INTERSECTION IMPROVEMENTS AT S-76 (MIDWAY ROAD), L-616 (CRESTVIEW ROAD), AND L-617 (HARRIETT CIRCLE) PROJECT UPDATE - P038292

SCDOT comment response from February 27, 2024 Public Information Meeting held in Anderson

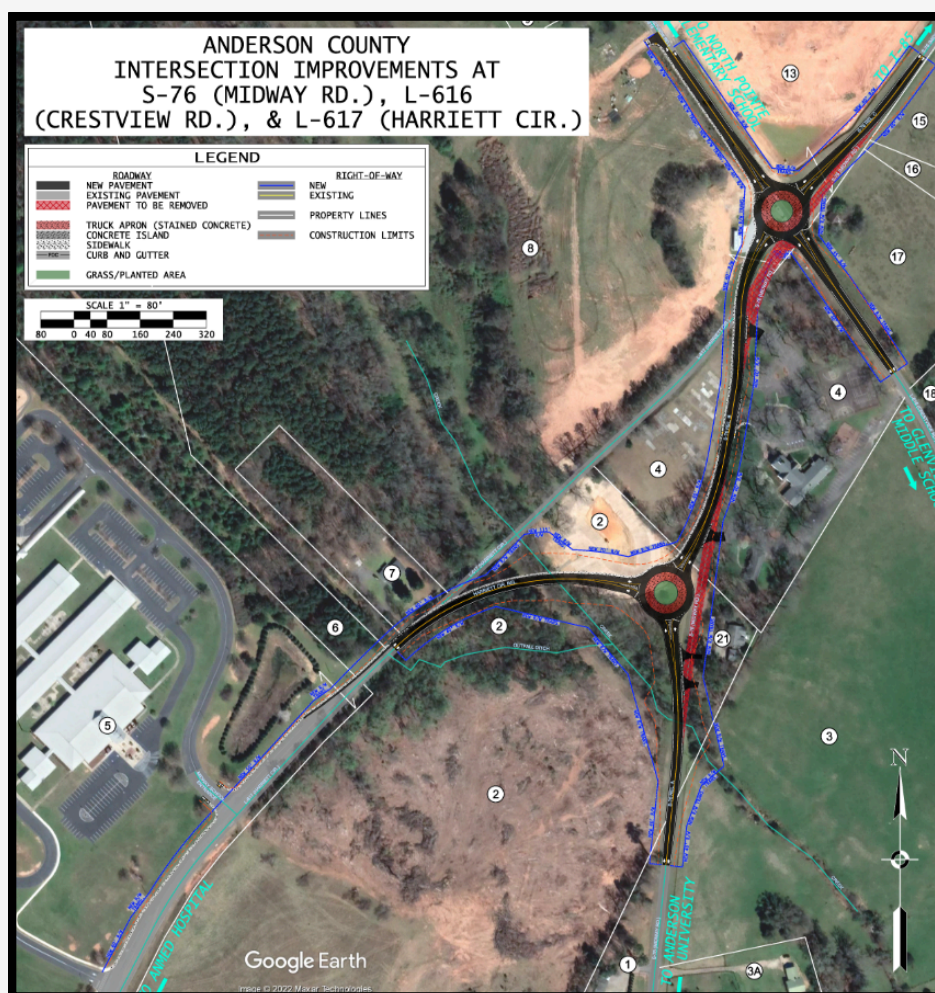
Comments received regarding speeds included concerns that speeding may increase without stop signs and traffic signals. However, roundabouts are a traffic calming device, slowing typical driving speed on arterial roads while reducing the stop and start traffic behavior associated with signalized intersections. Posted speed limits of Harriett Circle, Crestview Road, and Midway Road will remain the same.
